ABILENE RESTORATION  
MINISTRIES, INC.  
2018 BEECH STREET

10-3-2025  
ADDENDUM A  
10-26-2025

ABILENE RESTORATION  
MINISTRIES, INC.  
ABILENE, TEXAS

SECOND FLOOR PLAN - PLUMBING

571-1-10.DWG  
1.10

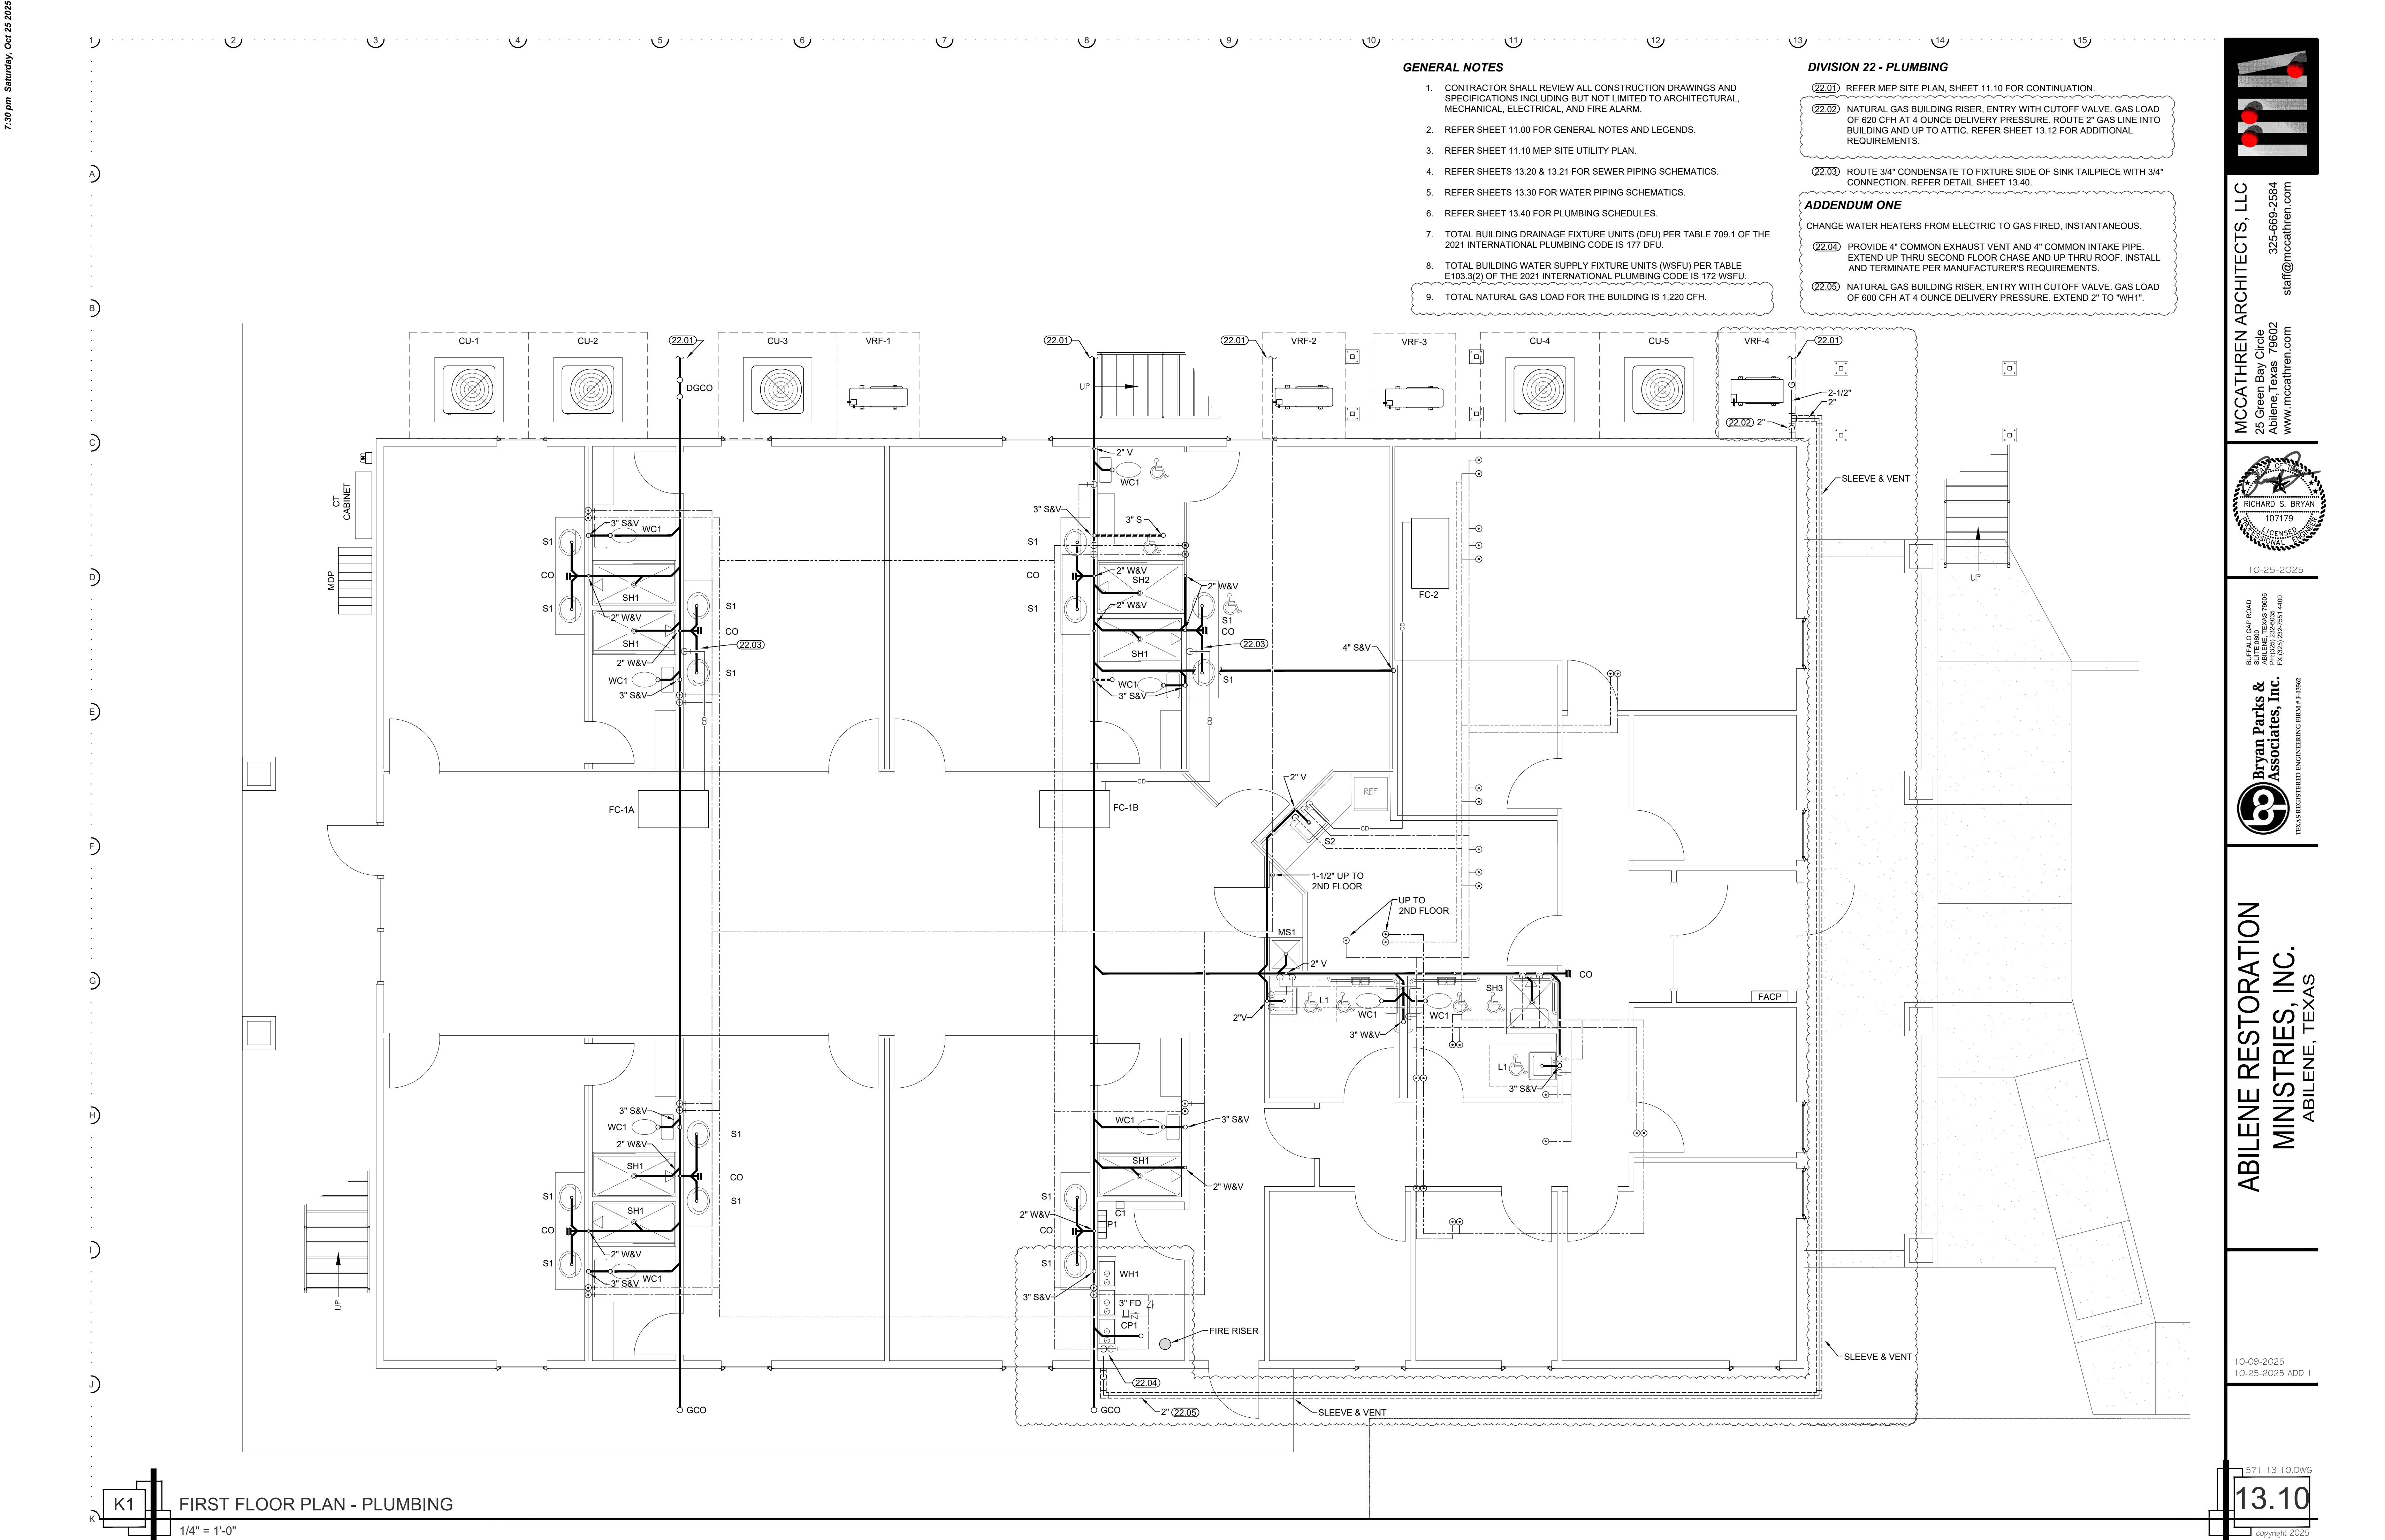
CHANGE WATER HEATERS FROM ELECTRIC TO GAS FIRED, INSTANTANEOUS.

(22.02) PROVIDE 4" COMMON EXHAUST VENT AND 4" COMMON INTAKE PIPE. EXTEND UP FROM FIRST FLOOR AND UP THRU ROOF. INSTALL AND TERMINATE PER MANUFACTURER'S REQUIREMENTS.

(22.03) PROVIDE 2" EXHAUST VENT AND 2" INTAKE PIPE UP THRU ROOF. INSTALL AND TERMINATE PER MANUFACTURER'S REQUIREMENTS.

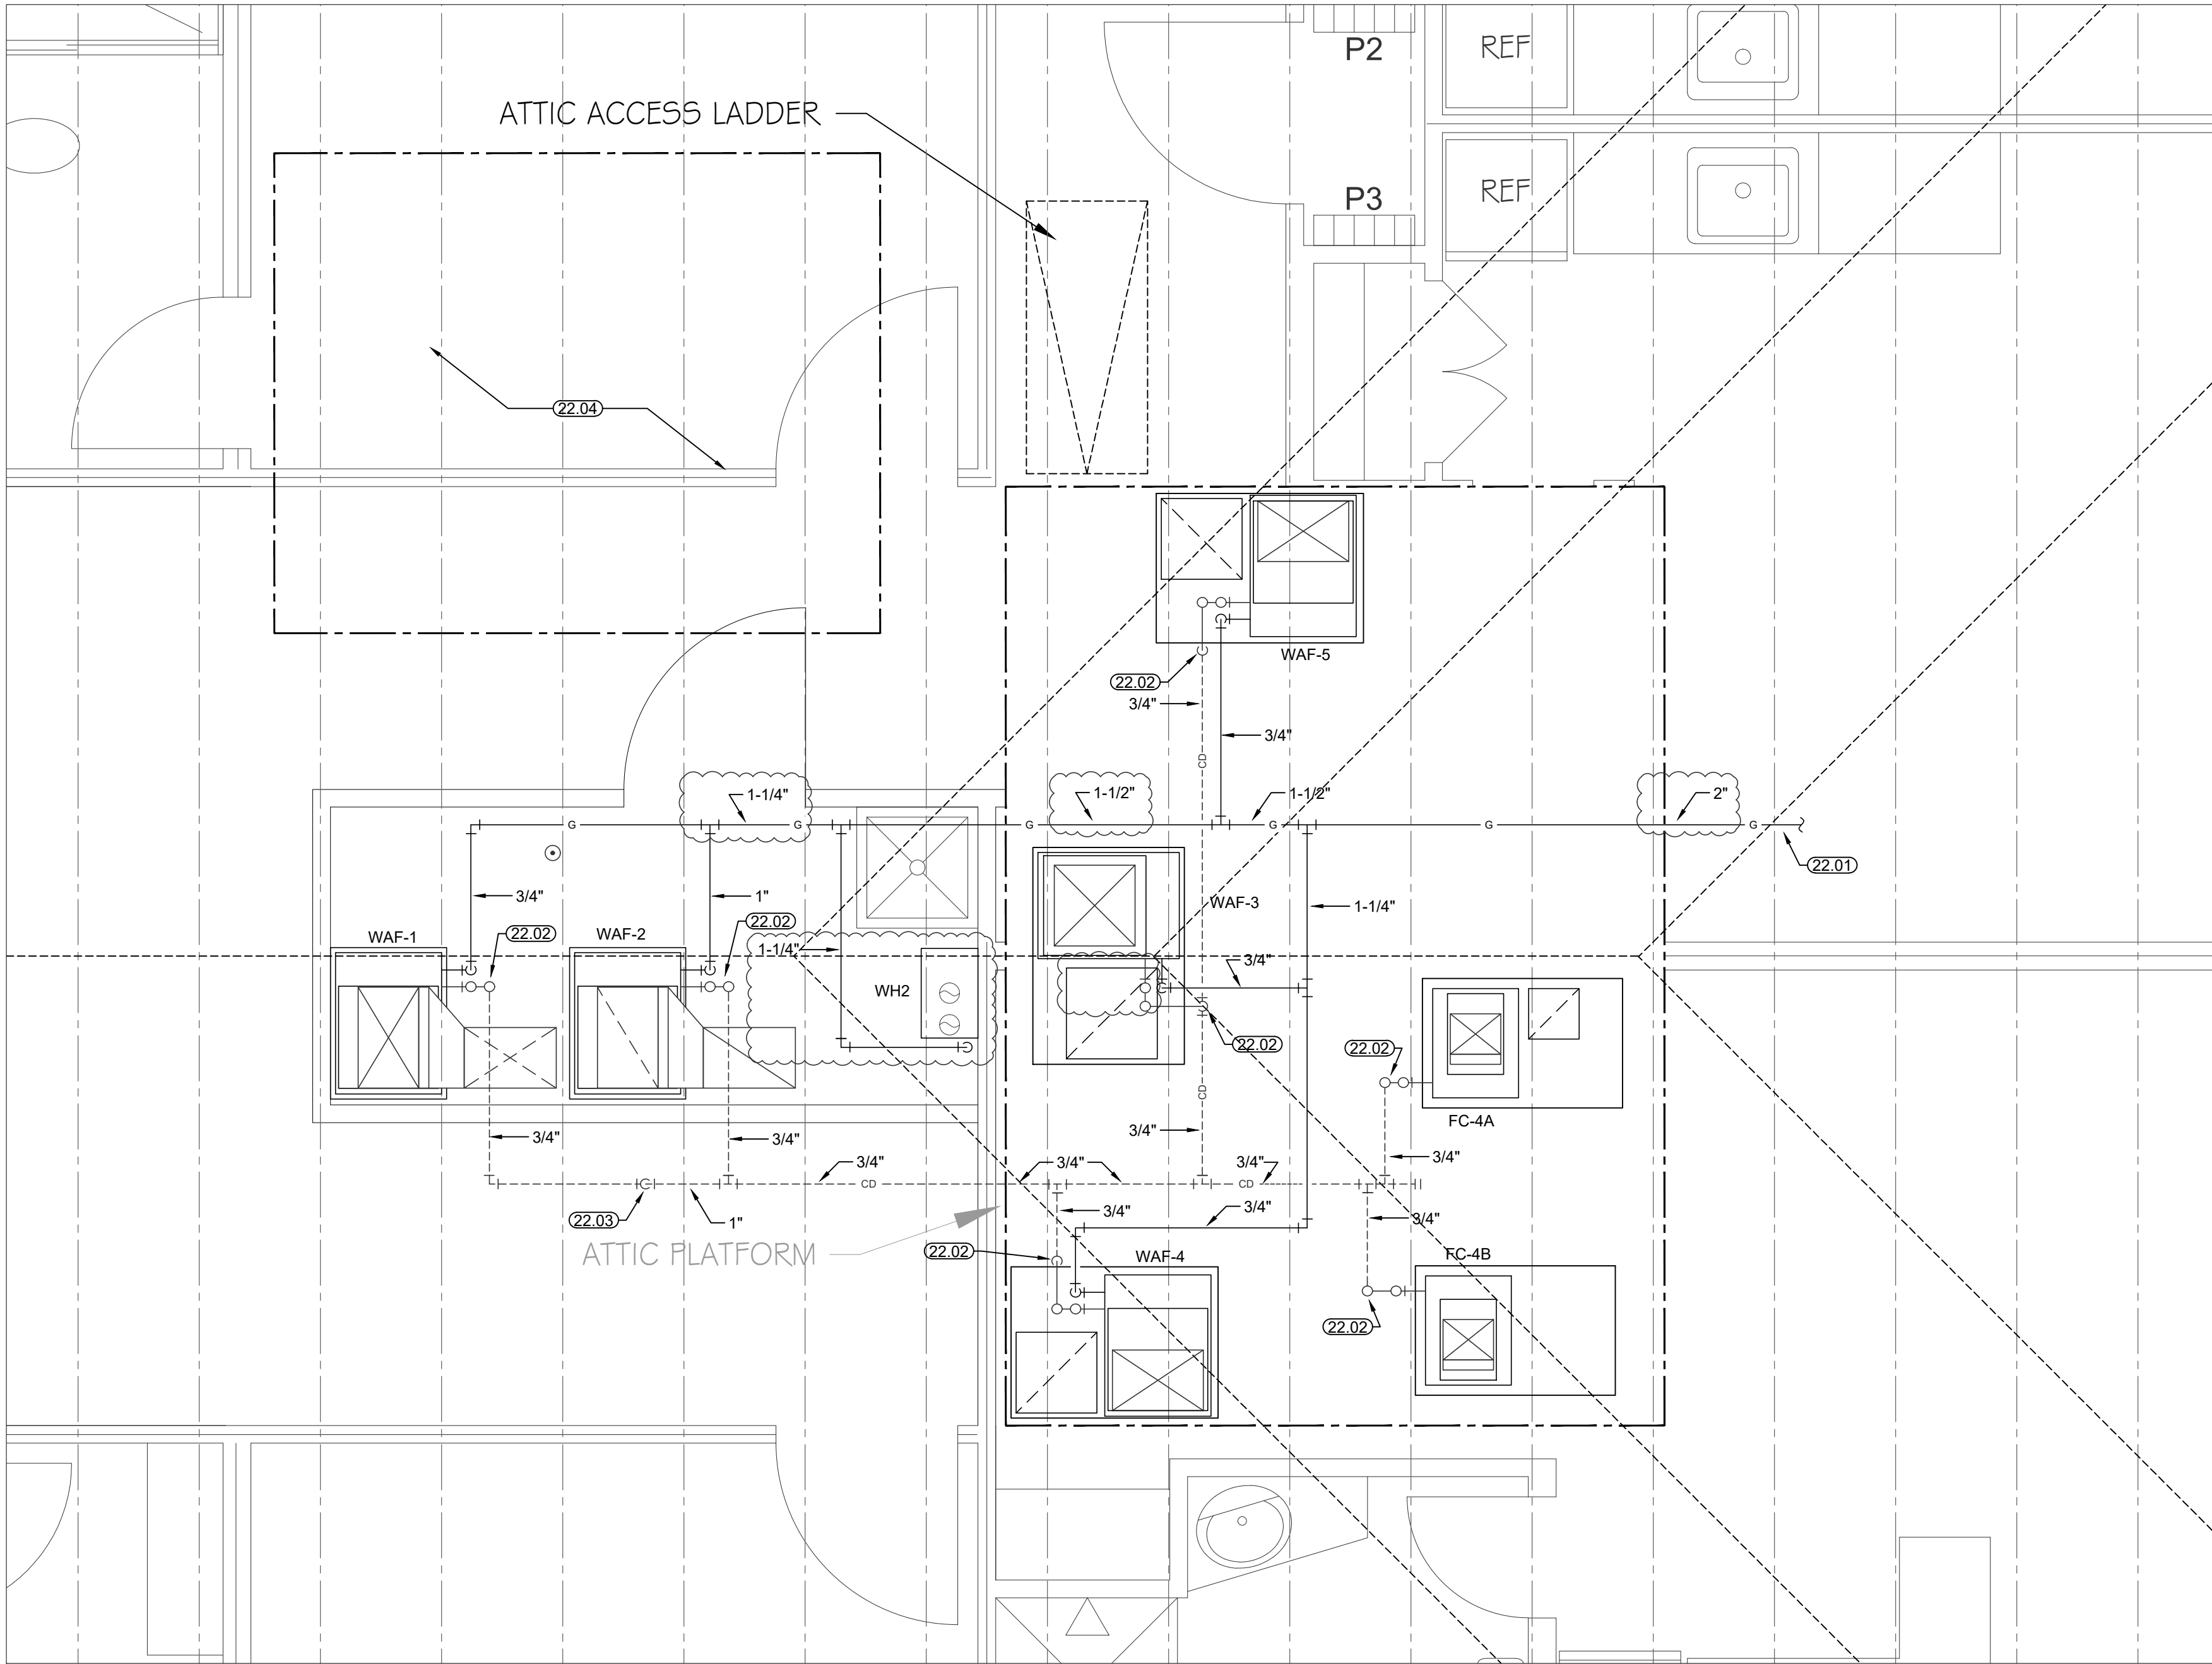
- (22.01) 2" GAS LINE FROM BUILDING ENTRY, REFER SHEET 13.10 FOR ADDITIONAL REQUIREMENTS.
- (22.02) ROUTE FULL SIZE CONDENSATE FROM UNIT DOWN TO 1ST FLOOR CEILING SPACE AND CONNECT TO COMMON CONDENSATE DRAIN.
- (22.03) ROUTE 1" CONDENSATE DRAIN DOWN WALL, TURN OUT OF WALL 6-INCHES ABOVE 1ST FLOOR SERVICE SINK AND TERMINATE WITH 90 ELBOW TURNED DOWN.
- (22.04) ALL GAS FLUE PIPE TO BE EXTENDED TO NORTH SIDE OF ROOF RIDGE AND LOCATED WITHIN THE DESIGNATED BOUNDARY.

CHANGE WATER HEATERS FROM ELECTRIC TO GAS FIRED, INSTANTANEOUS. REVISED GAS PIPE SIZES.

WATER HEATER "WH2" (ONE UNIT) SCHEMATIC

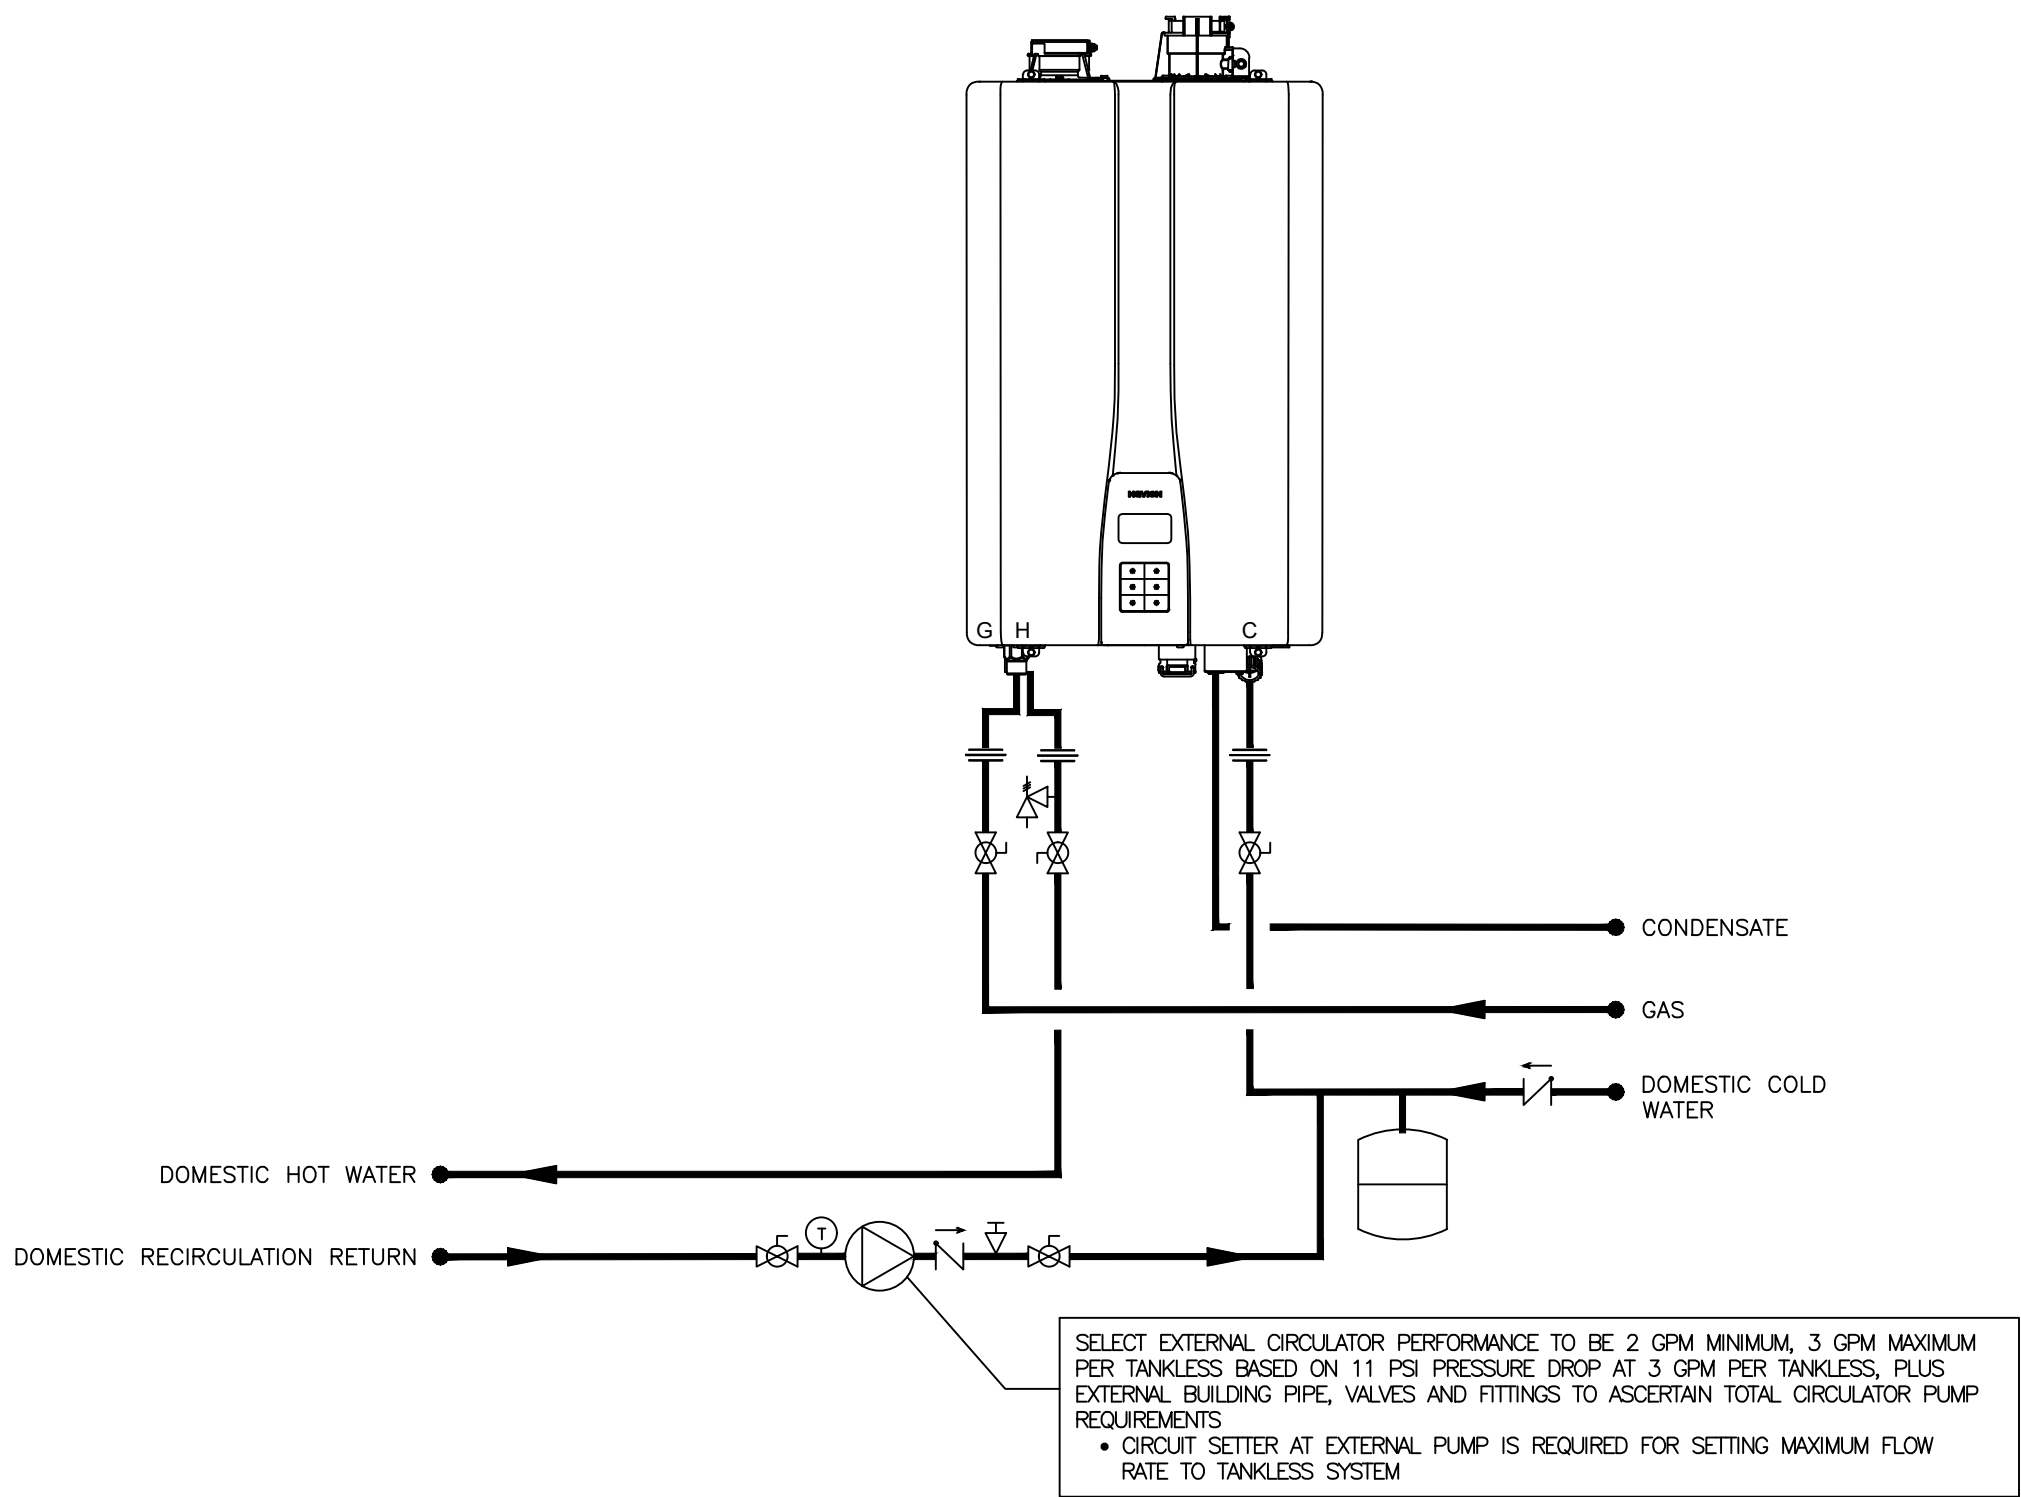
CHANGE WATER HEATERS FROM ELECTRIC TANK TYPE TO GAS FIRED, INSTANTANEOUS.

| INSTANTANEOUS GAS WATER HEATER SCHEDULE (1-UNIT SYSTEM)                                                                                                                                                                                                                                                                                                                                                                                                                                                                               |                                            |                   |           |                   |                       |              |                     |             |                       |                               |      |      |      |                              |    |    |     |                           |              |               |            |        |          |       |
|---------------------------------------------------------------------------------------------------------------------------------------------------------------------------------------------------------------------------------------------------------------------------------------------------------------------------------------------------------------------------------------------------------------------------------------------------------------------------------------------------------------------------------------|--------------------------------------------|-------------------|-----------|-------------------|-----------------------|--------------|---------------------|-------------|-----------------------|-------------------------------|------|------|------|------------------------------|----|----|-----|---------------------------|--------------|---------------|------------|--------|----------|-------|
| WH2                                                                                                                                                                                                                                                                                                                                                                                                                                                                                                                                   | INDOOR TANKLESS CONDENSING HIGH EFFICIENCY | 1                 | GAS       | 0.96              | 13,300                | 199,900      | 70 - 140            | 120         | 3.9                   | 2"                            | 3/4" | 3/4" | 3/4" | 120                          | 60 | 1  | 2   | 17.3                      | 13.2         | 28.8          | 73         | NAVIEN | NPE240S2 | ALL   |
